**THE PORT AUTHORITY OF NEW YORK AND NEW JERSEY  
TWO MONTGOMERY STREET - 1st FLOOR  
JERSEY CITY, NJ 07302**

**ADDENDUM NO. 2**

TO PROSPECTIVE BIDDERS ON CONTRACT **JFK-944.805** – JOHN F. KENNEDY INTERNATIONAL AIRPORT – REPLACEMENT OF SWITCH HOUSE 1 EMERGENCY GENERATOR

**Addendum No. 2  
SK-M001-01**

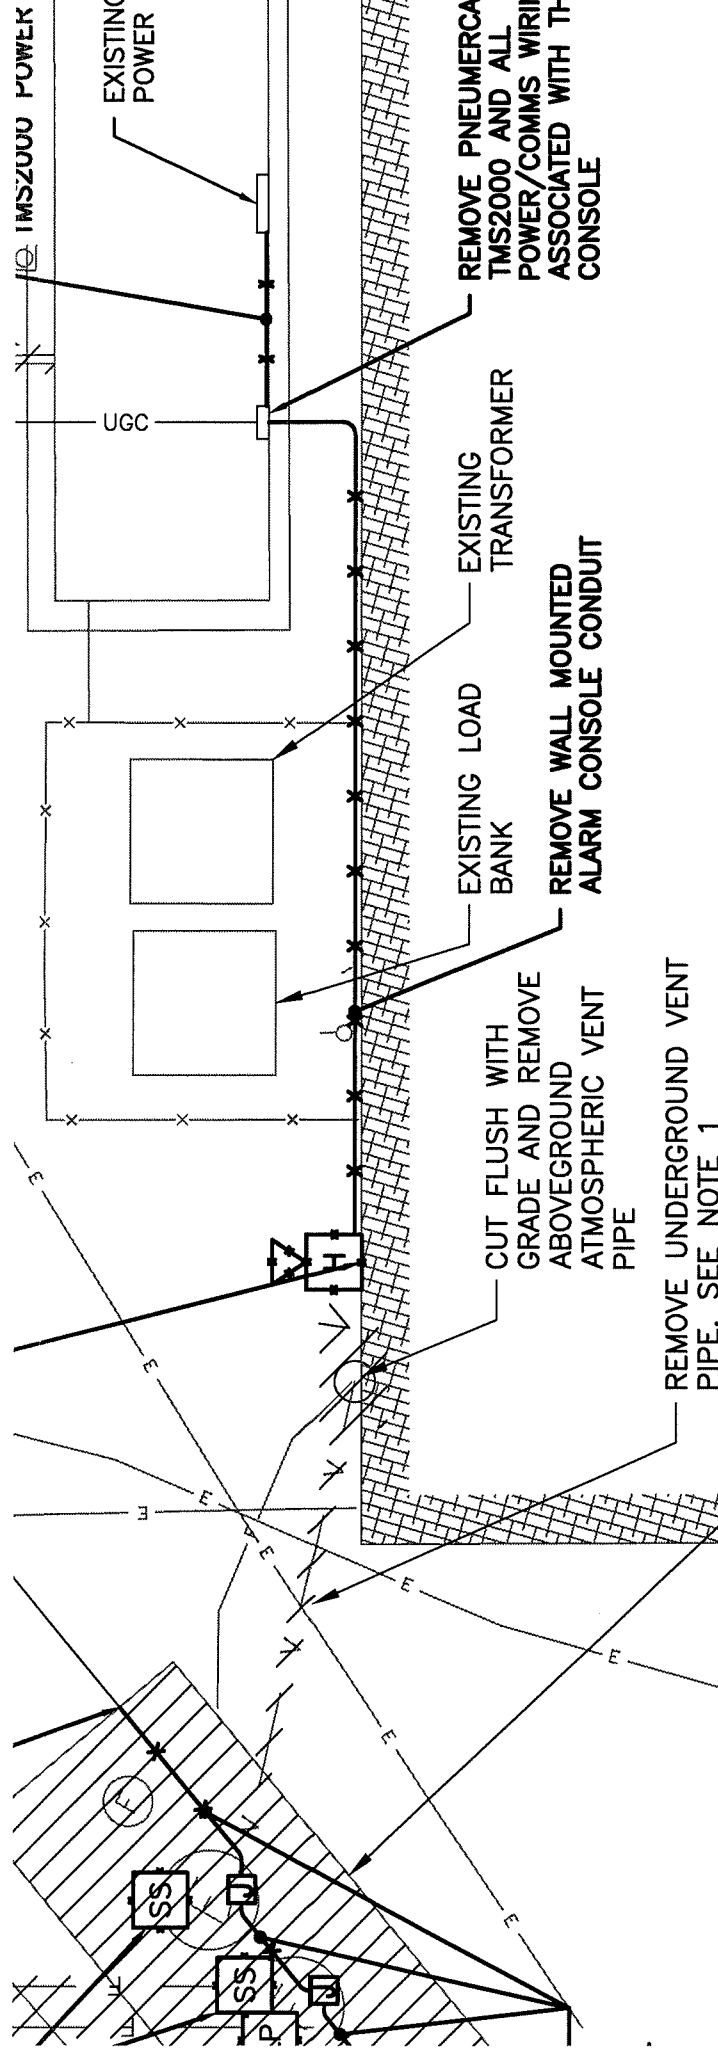
M001 - Revise the drawing as shown in Sketch SK-M001-01 which is attached hereto and made a part hereof.

REMOVE 4,000 GALLON DOUBLE WALL FIBERGLASS UNDERGROUND STORAGE TANK. SEE NOTE 1. TOP OF TANK 40"± BELOW EXISTING GRADE
